SALAZAR SPRING SUBDIVISION

PRELIMINARY / FINAL

LAND USE SUMMARY

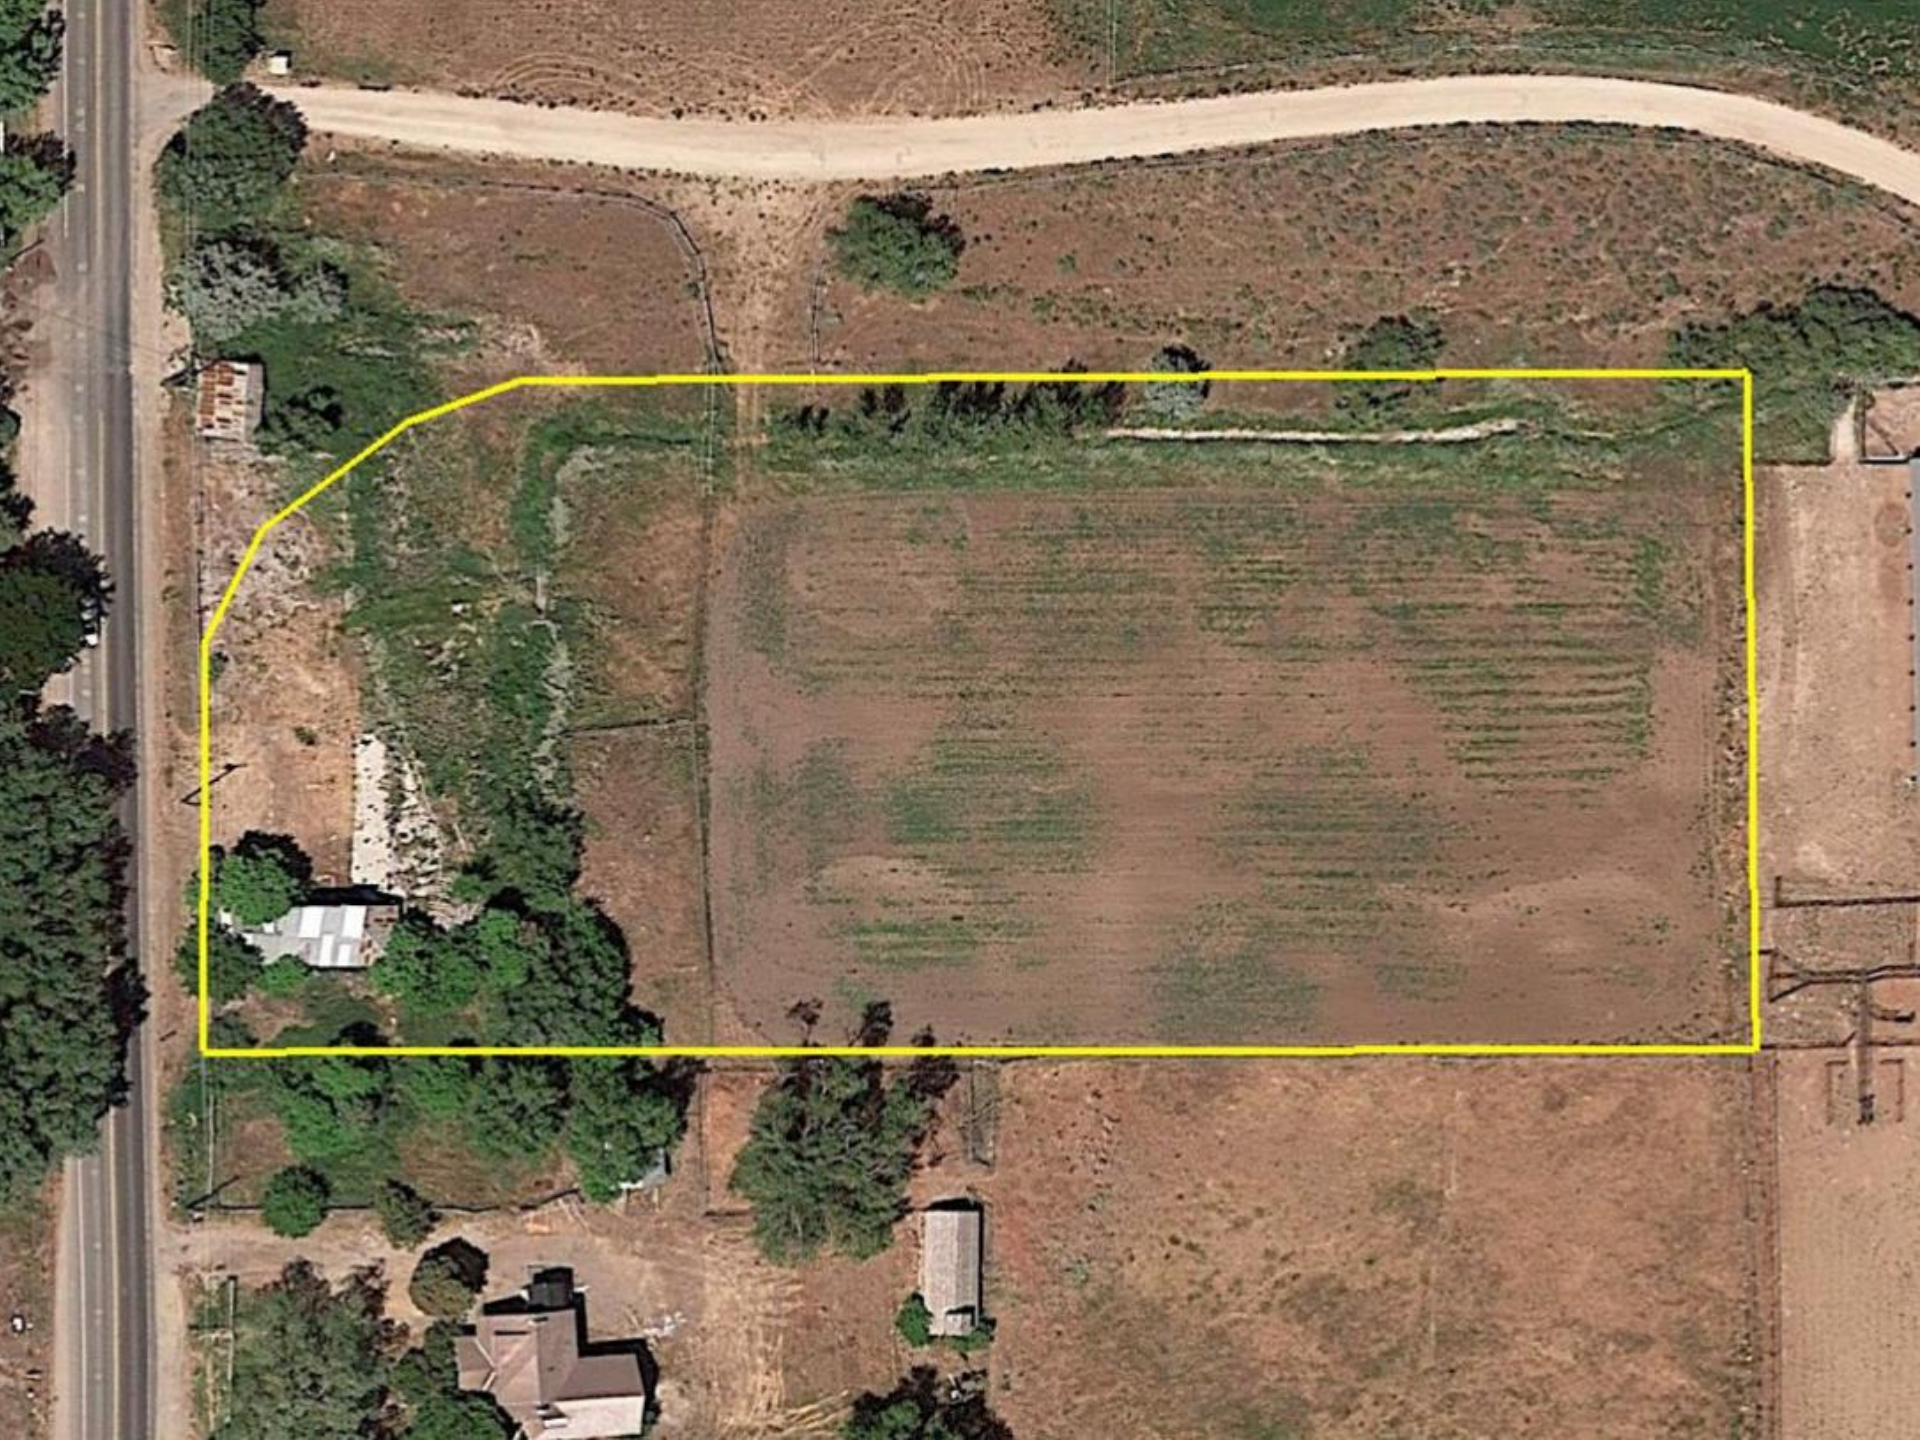
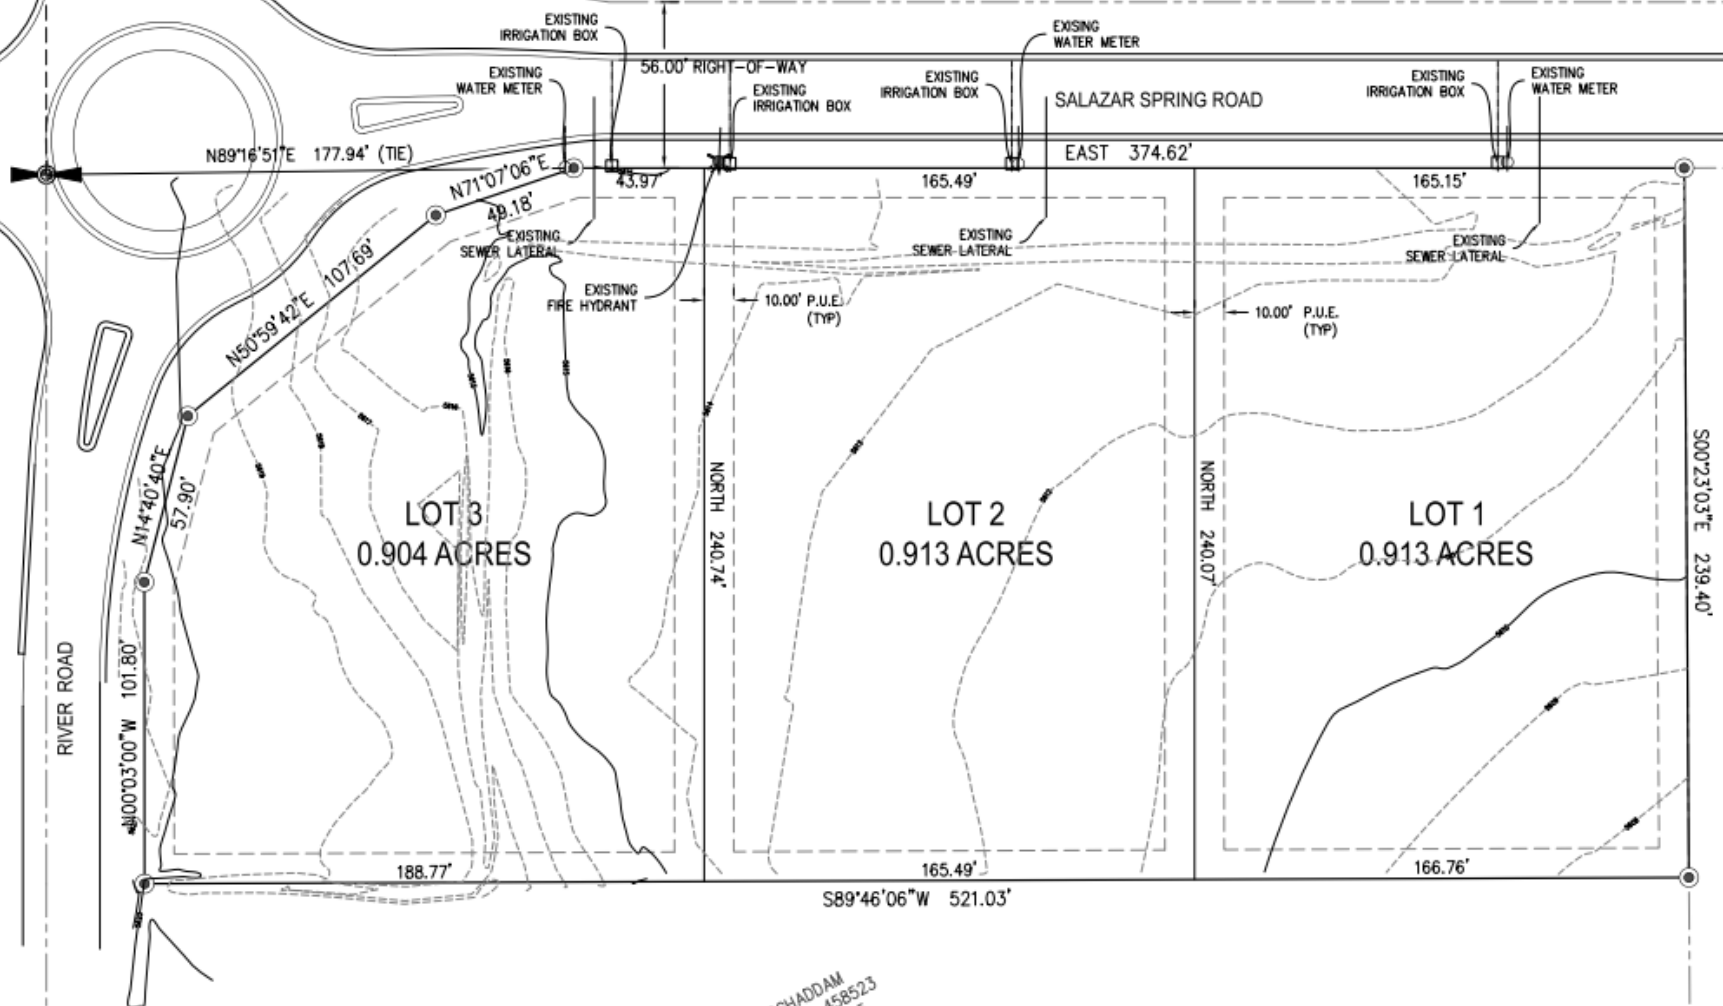
- The proposed lots meet the minimum frontage and width requirements for the RA-1-43 zoning district
- The proposed lots meet the minimum acreage requirements as stated in the Whitaker Annexation Agreement
- The proposal does meet the intent of the General Plan for the RA-1-43 zoning district

- Lot 3 River Road access is removed from the proposed plans to comply with the language in the Whitaker Annexation Agreement
